## PUD Amendment – Monument Sign Application

Site: 27777 Southfield Road  
Applicant: Allen Industries  
Plan Date: April 12, 2024  
Zoning: PUD – Village Center District  
Parcel ID: 24-14-432-006  
Proposal: Restaurant Monument Sign

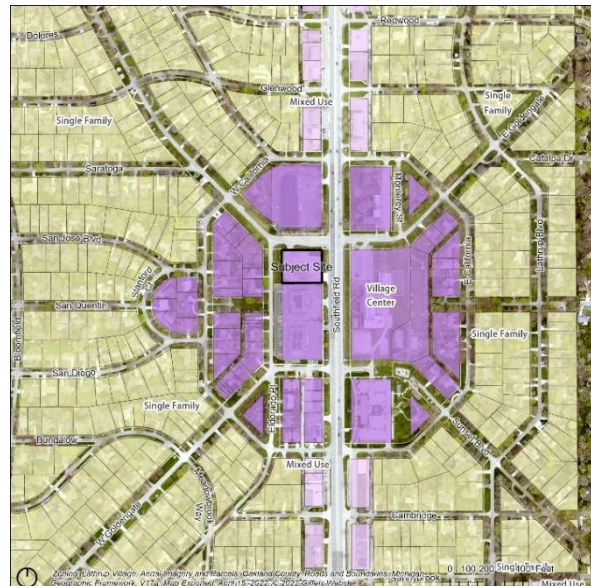
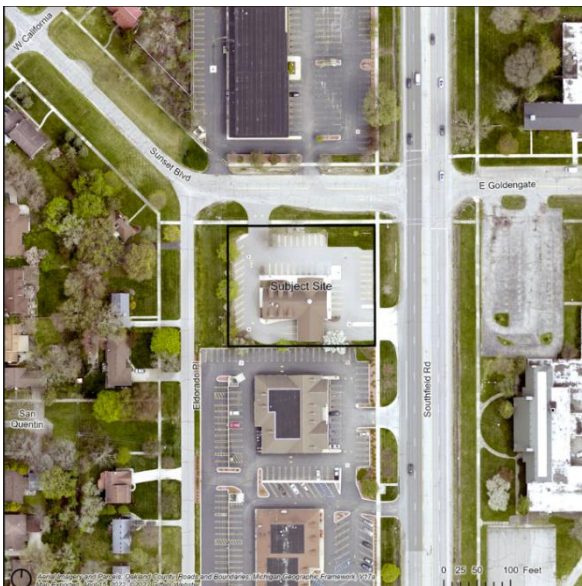
Monument signs are not permitted in the Village Center (VC) zoning district; however, as part of the overall PUD consideration, the preexisting monument sign structure was approved by the Planning Commission and City Council if it were to remain and be reused by the new drive-through restaurant facility. The preexisting sign structure was approximately 13'-6" in length and was determined to be located within the 10' minimum setback along Southfield Road. An image of the former sign structure is shown below for reference.

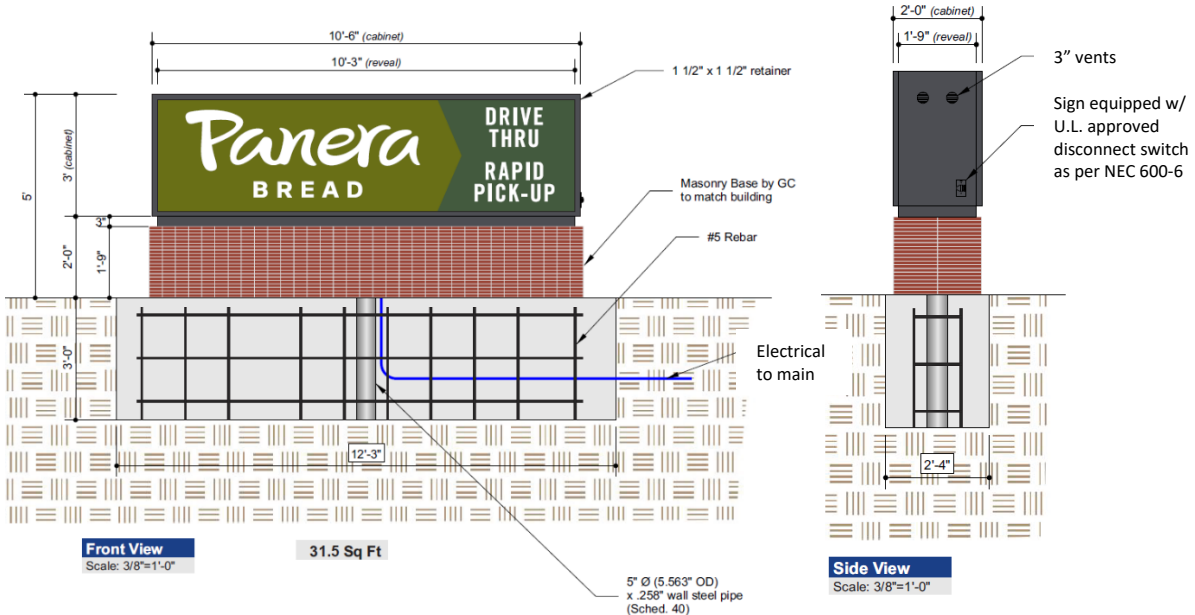
Ordinance Sign Standards – VC District				
Sign Type & Standard	Zoning Ord. Section	Required	Provided	Comments
MONUMENT SIGN (GROUND) - Not Permitted in the VC District				
<b>Location</b>				
(Pre) Existing	52-24.D.	10' min. front & side yard setbacks	< 10' min. along Southfield Rd. & Sunset Blvd.	<b>Existing non-conforming. Masonry structure was to remain.</b>
Proposed	52-24.D.	10' min. front & side yard setbacks	10' min. along property lines	Compliant
	52-23.B.	Not in the clear vision zone.	At the clear vision zone.	Compliant <sub>1</sub>
<b>Size</b>				
Max Area	52-24.D.	40 sf. per side	30.75 sf. per side	Compliant
Max Height		5' from ground level to top of sign	5'-0"	Compliant
Number		1 per parcel	<b>1 (monument) sign</b>	<b>Not permitted in the VC District</b>
Max. Total Area	52-25.A.1.	No more than 3x the surface display area (92.25 sf.)	52.5 sf.	Compliant <sub>2</sub>
Min. Base Size & Material	52-25.A.2.	12 in. high min. Masonry	1 ft. 9 in. high Masonry	Compliant <sub>3</sub>

Street Number	52-25.A.3.	On sign face or supporting structure	<b>No street numbers shown on sign or base.</b>	<b>Not Compliant</b>
Min. Height of all Letters/Numbers	52-25.A.4.	6 in. (≥ 45 mph.)	<b>Dimensions not provided.</b>	Appears Compliant

1. The revised site plan shows the 25' x 25' clear vision zone/triangle to be partially within the right-of-way on the site plan. When corrected, the location of the monument sign clips the edge of the triangle. When installed, the applicant shall verify no part of the proposed sign will encroach into the 25' x 25' clear vision zone.
2. The surface display area for each side of the sign is 30.75 square feet (3' x 10.25'); therefore, the total area, including the sign and all supporting structure components for the monument sign shall be limited to no more than 92.25 square feet (30.75 sf x 3). The total sign and supporting structure amounts to 52.5 square feet for each side (5' x 10'-6"), which complies with the maximum 92.25 square foot limit.
- 3.

*The plans indicate the illumination of the sign will be internal.*

*As stated in number 3 above, the plans indicate the illumination of the sign will be internal and not back lit or externally lit.*

*There is no indication that the proposed sign will contain any of the above characteristics.*
